ENG-20-10547

ARROYO SECO NORTH  
VILLAGE 2 - UNIT 6  
PAVING PLAN

**FIELD DIRECTIVE 2**

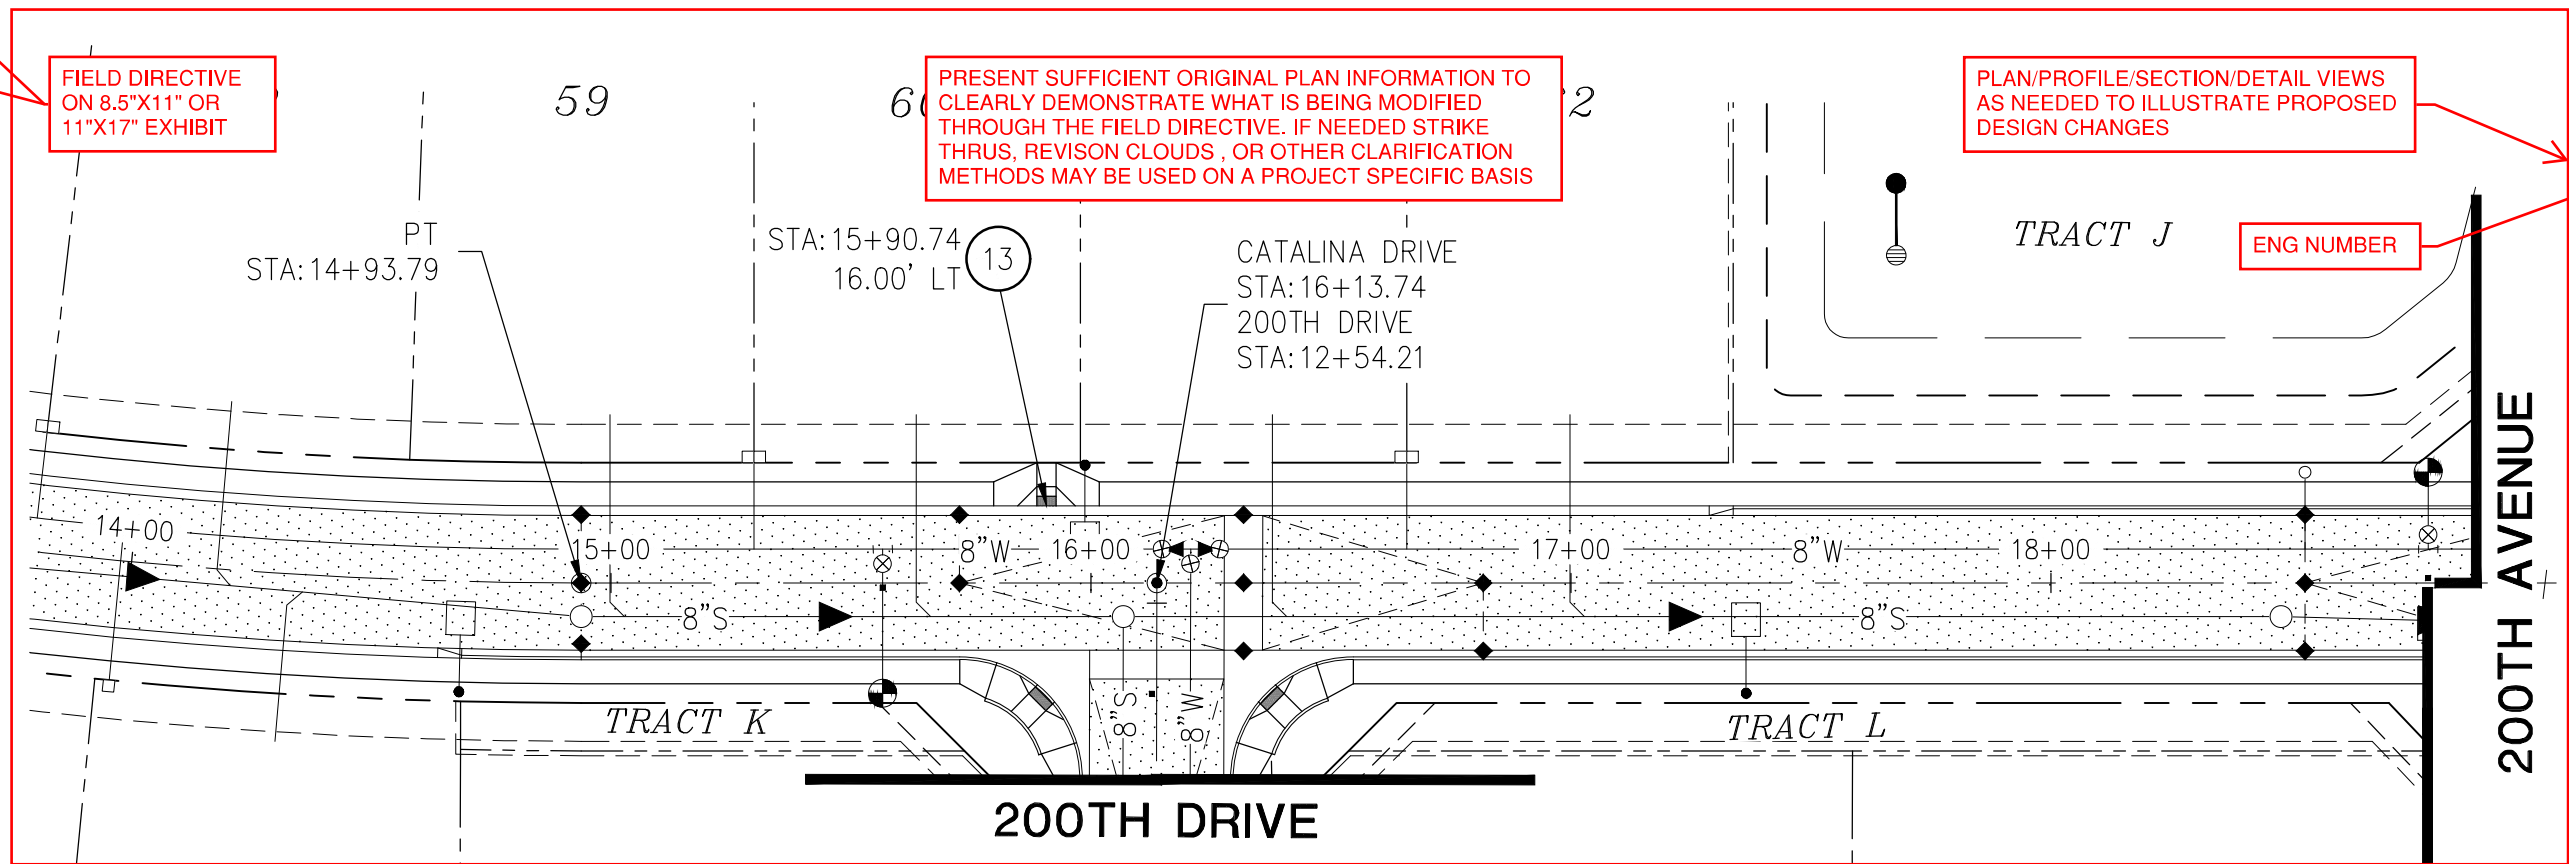
1. THE PURPOSE OF THIS FIELD DIRECTIVE IS TO CORRECT THE MID-BLOCK RAMP IN FRONT OF LOT 80.
2. SEE ARROYO SECO NORTH VILLAGE 2 -UNIT 6, APPROVED PAVING PLAN, SEE SHEET PV06 ENG-20-10547 FOR ADDITIONAL INFORMATION.

13) PAVING CONSTRUCTION  
CONSTRUCT MID-BLOCK RAMP WITH 4" CURB PER  
COB STD DTL 63250. 1 EA
